State of New Jersey
DEPARTMENT OF ENVIRONMENTAL PROTECTION
DIVISION OF HAZARDOUS WASTE MANAGEMENT

Re: IRP Phase III RI Work Plan, Naval Weapon Station Earle (NWSE)
Navy's Response to NJDEP Original Comments
Final Quality Assurance Project Plan (QAPP)
Final Health and Safety Plan

RI Work Plan Comments

Attachment
 #1

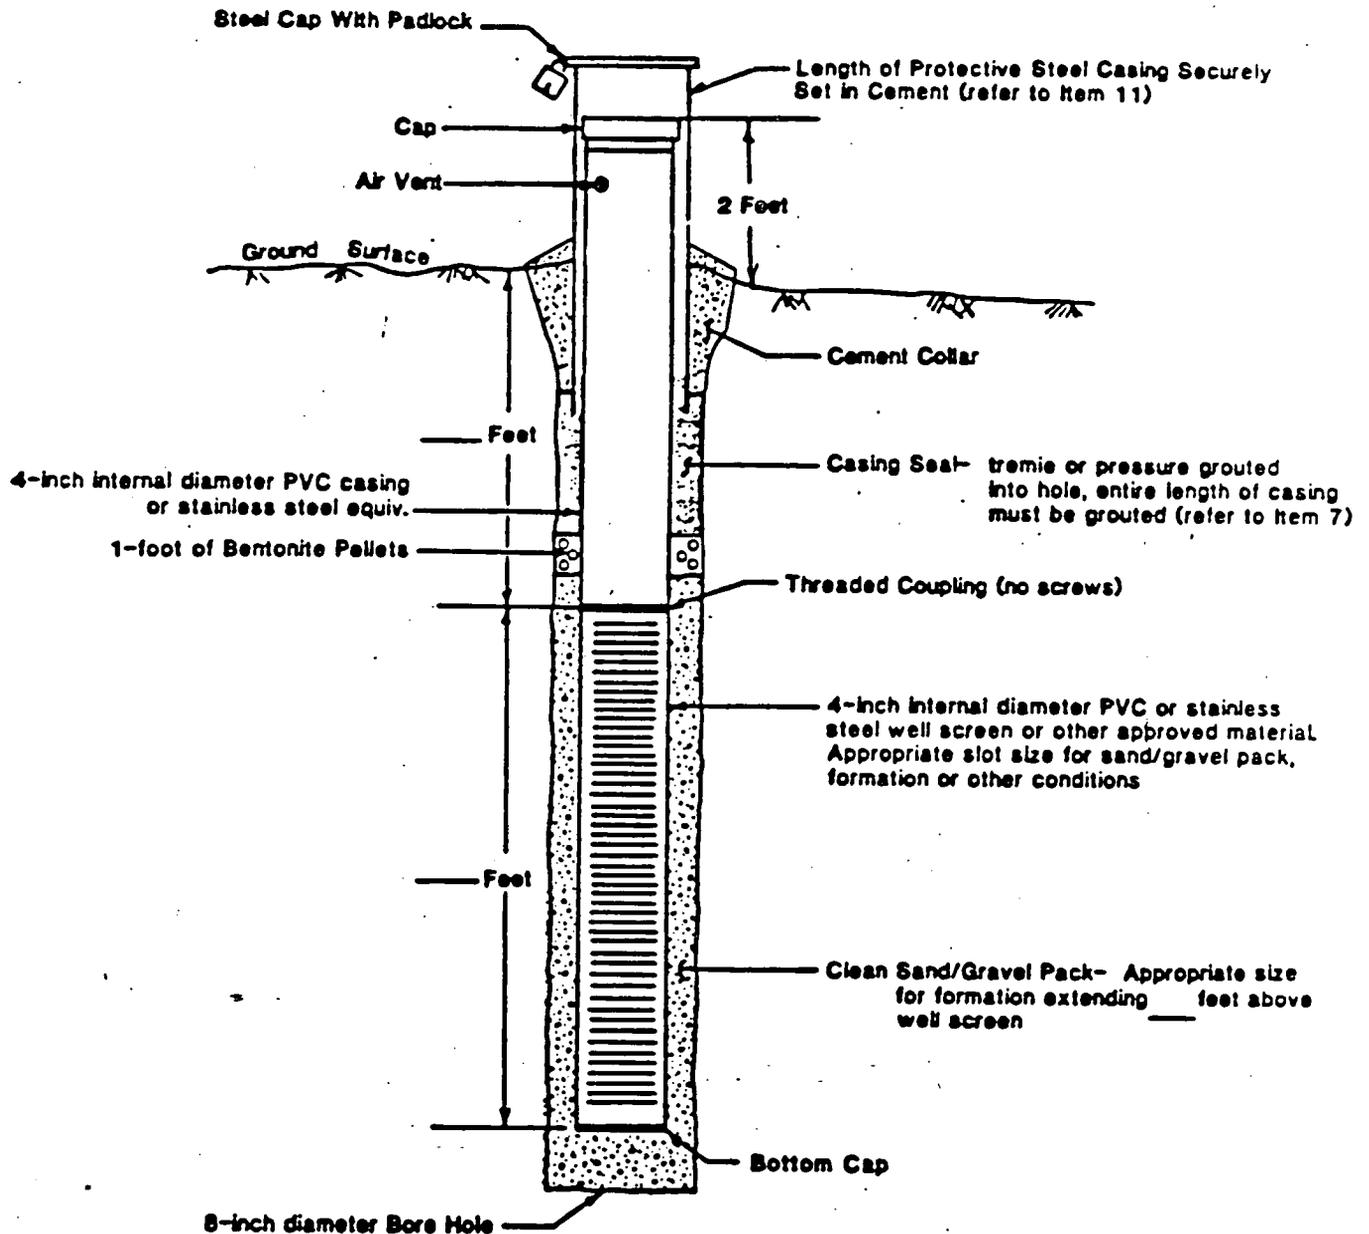
4. ITEM-7:
The well construction diagrams provided in the Final draft Quality Assurance Project Plan (QAPP), dated June 1990, page 2-9 are still incorrect. (See Attachment #1, for the appropriate monitor well specifications.)

The figure presented is incorrect and must be revised in accordance with attachment number 1.
 - √6. Section 2.4, Water Level Data Collection, page 2-8:

FIGURE 5-5 SITE 7 - LANDFILL SOUTH OF "P" BARRICADES MONITOR WELL LOCATIONS

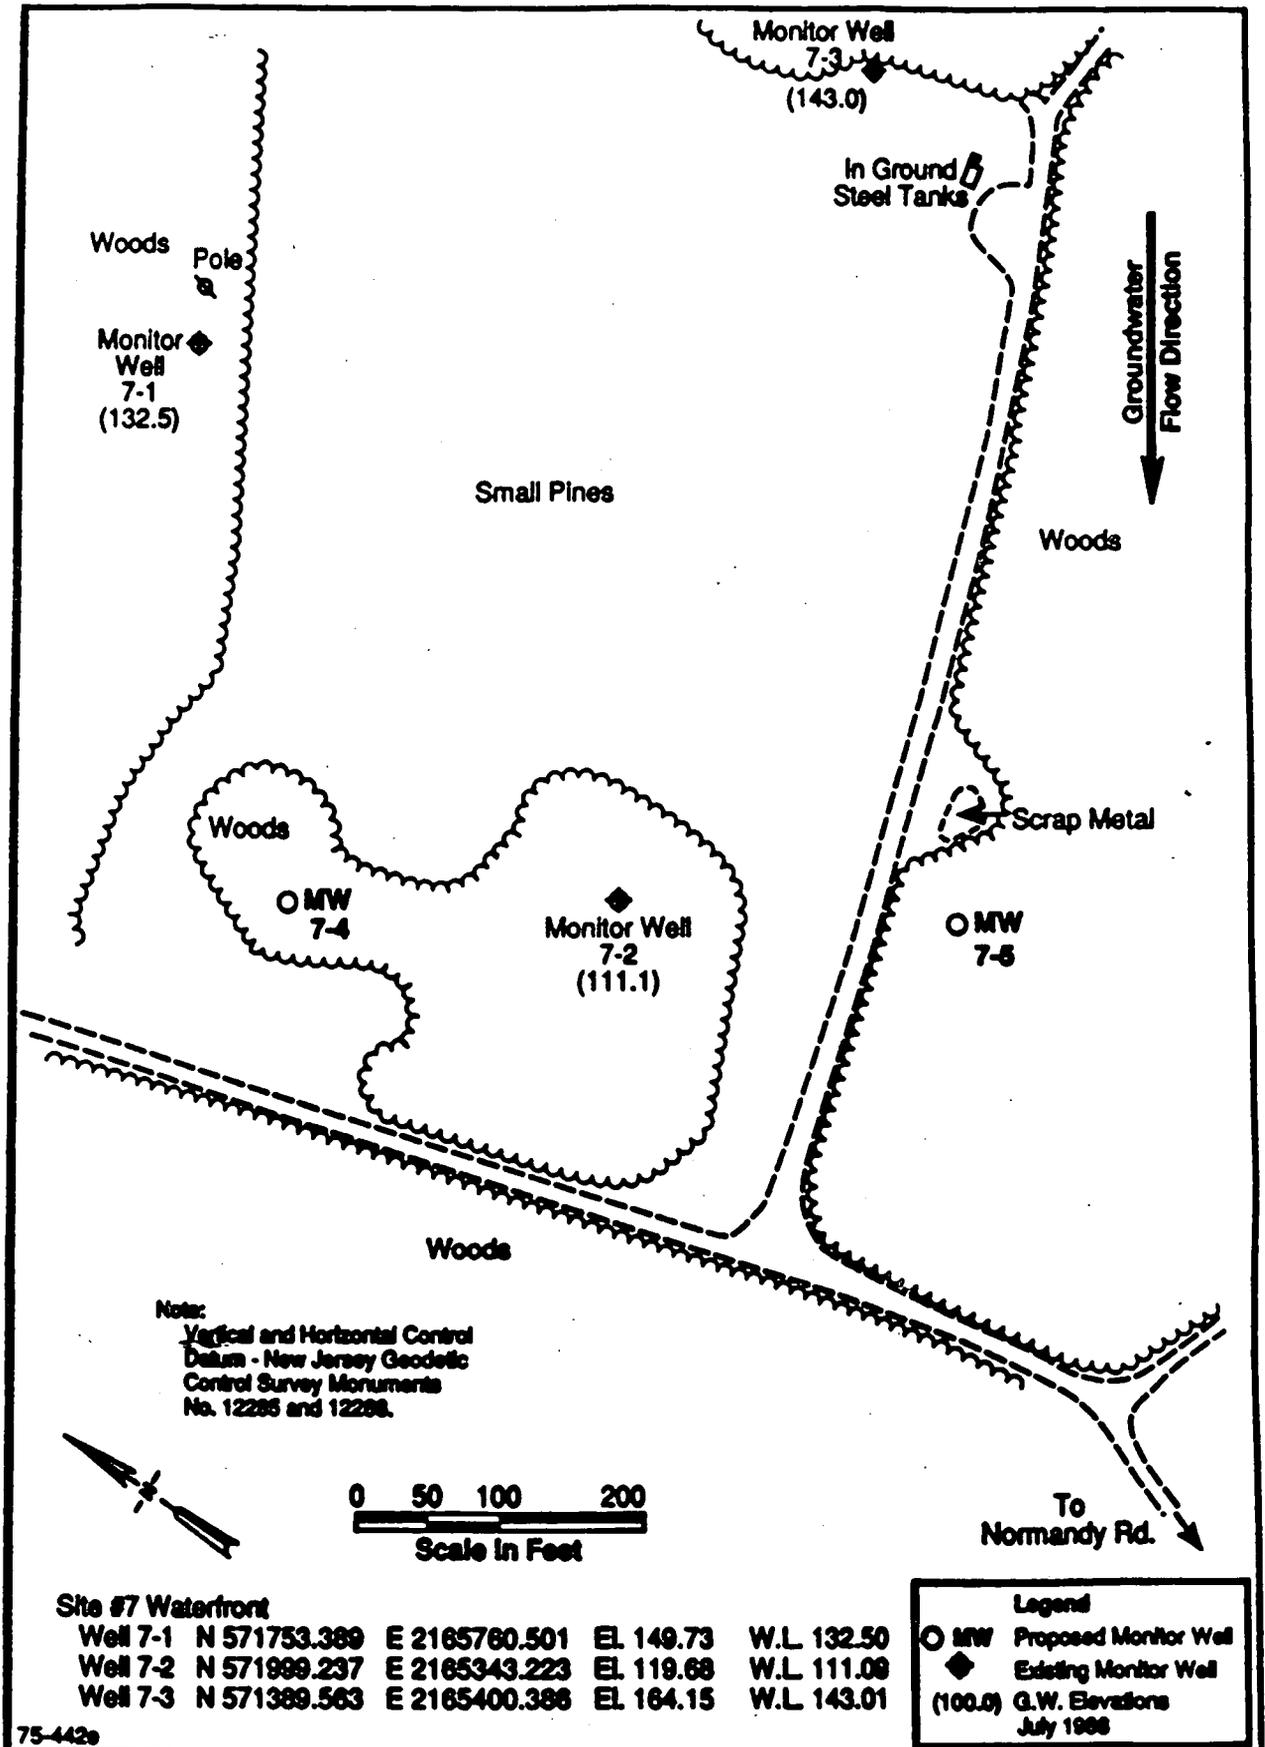
Item 6a, of this section of the response document discusses Compton Creek's approximate location and a drainage way leaving the site. Reportedly, this drainage way is depicted on the revised map in the northern portion of Site 7. (Attachment #2) There is no drainage way depicted on the referenced map, the contractor must revise the figure for Site 7 to incorporate this missing item.
